**City of Phoenix**  
PLANNING AND DEVELOPMENT DEPARTMENT

July 9, 2026

RE: MINOR AMENDMENT OF KIERLAND SKY PUD AMENDMENT (Z-14-A-20-2)  
SOUTHEAST CORNER OF KIERLAND BOULEVARD AND MARILYN ROAD

## Open Space

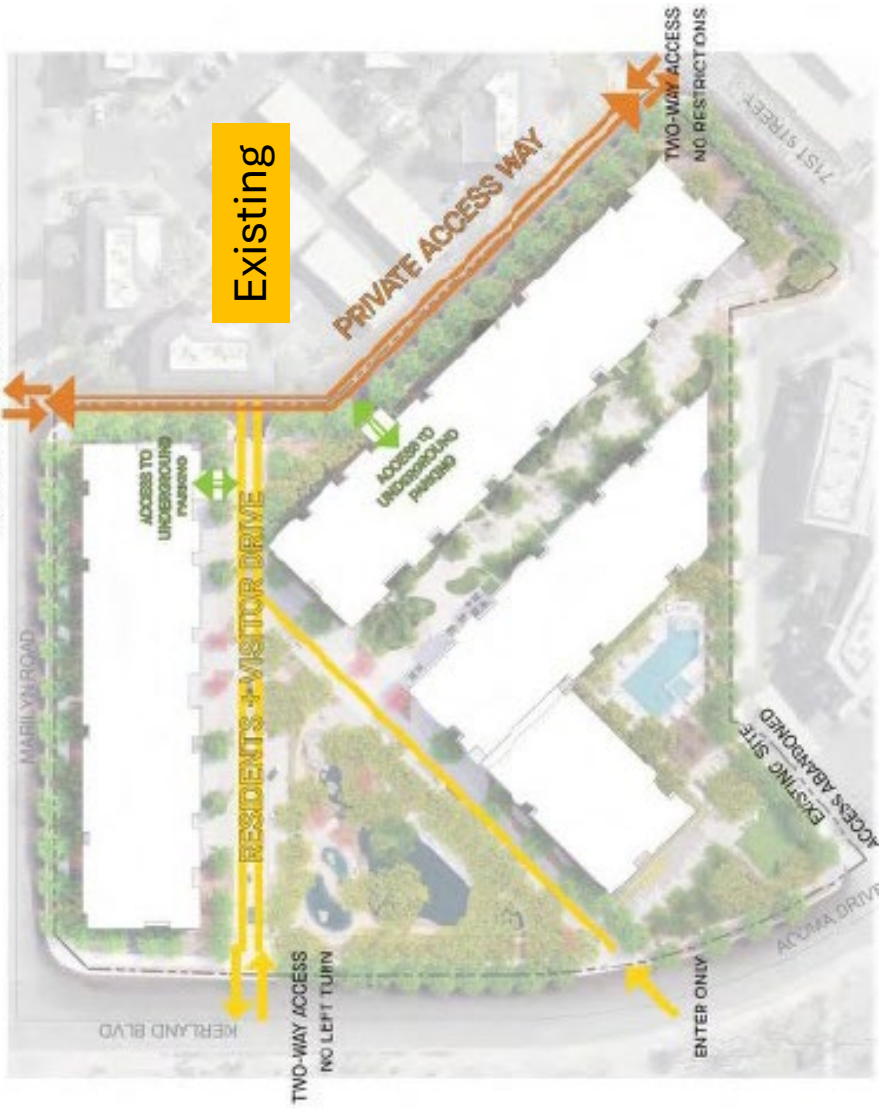
- The total open space provided is .4% more than the site plan in the approved PUD.
- The focal garden has been increased from 29,000 SF to 36,000 SF and been shifted south towards the single-family residential neighborhood, see above.
- Most of the public open space in the proposed site plan is facing Kierland Boulevard as it does in the approved site plan.
- The buildings are arranged so as not to create a wall of buildings along Kierland Boulevard.
- The open space still provides a connection between the multifamily residential neighborhoods to the southwest.
- There are still four types of open space; however, the proposed site plan has two dog parks instead of one and four resident courtyards instead of one.

Access

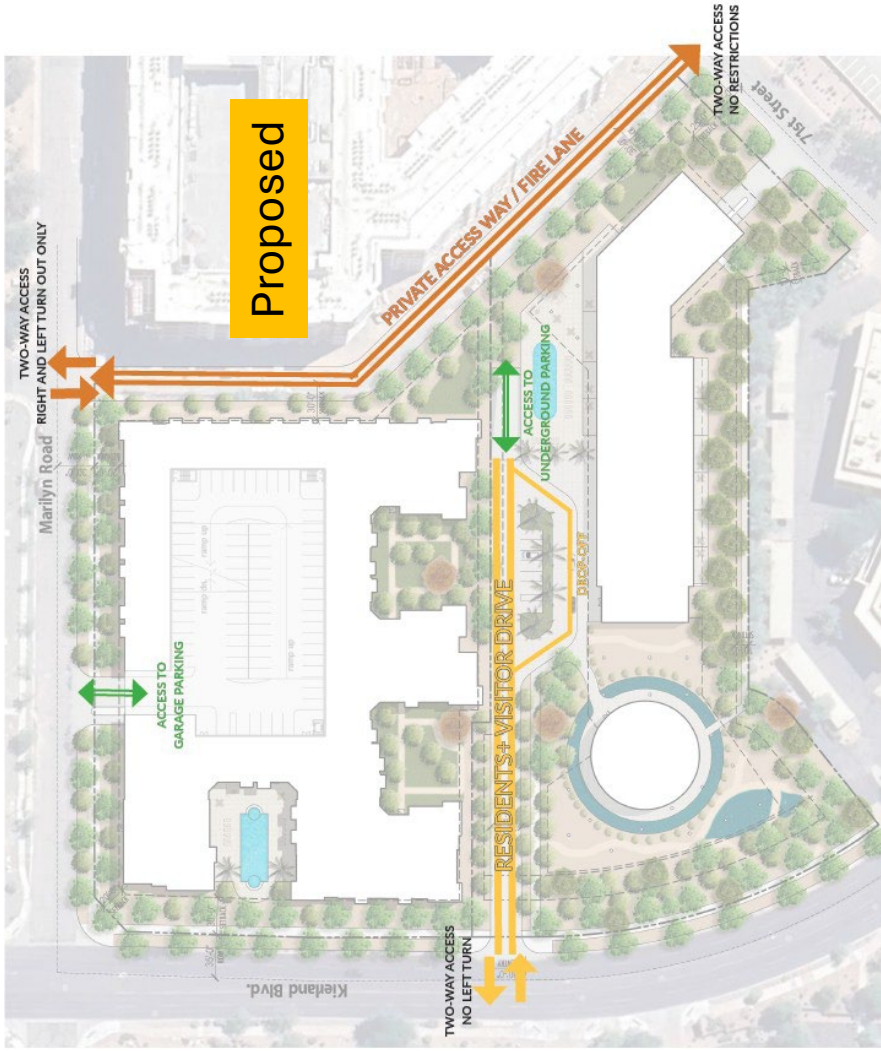
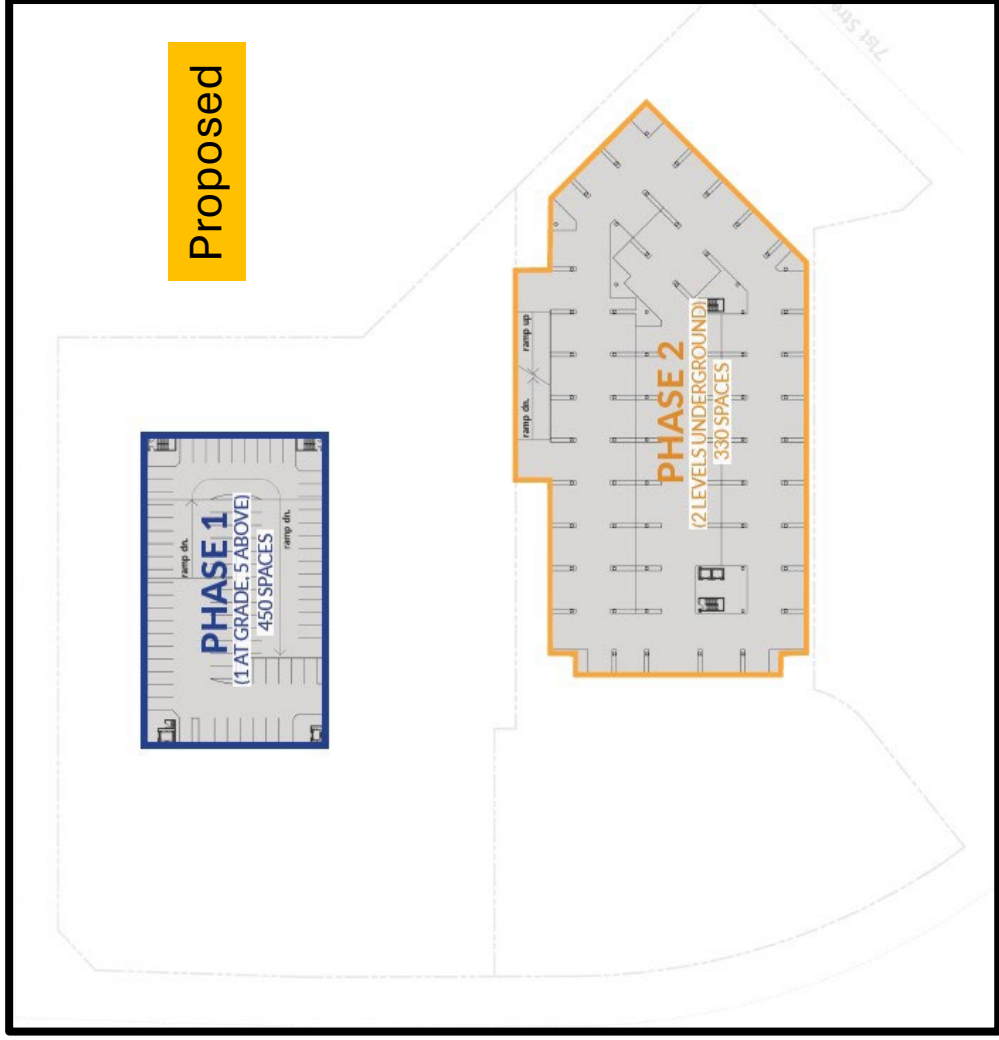
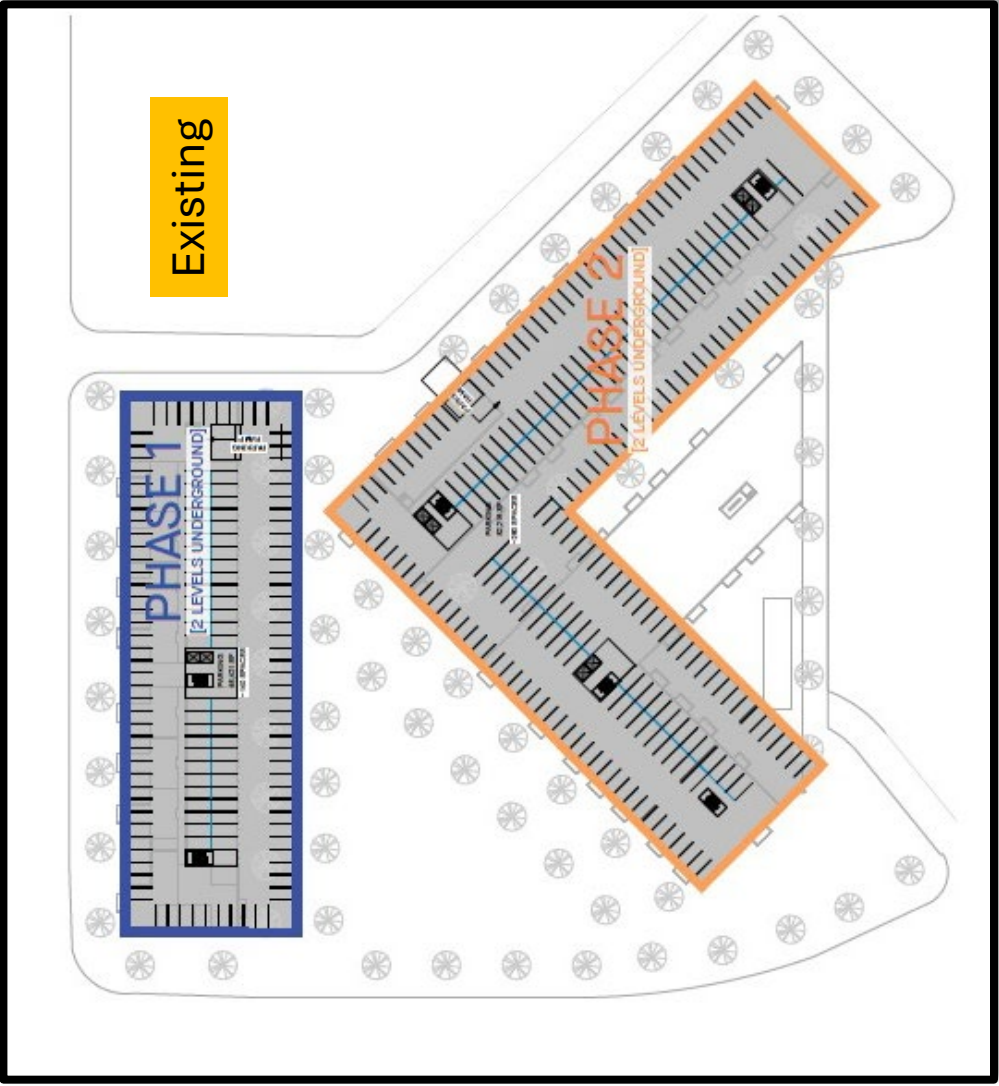
Access for both plans is very similar; however, the number of access points along Kierland Boulevard has been reduced from two to one. This is in response to Traffic’s initial comments on a FACT submittal where they stated that they preferred one driveway access off Kierland.
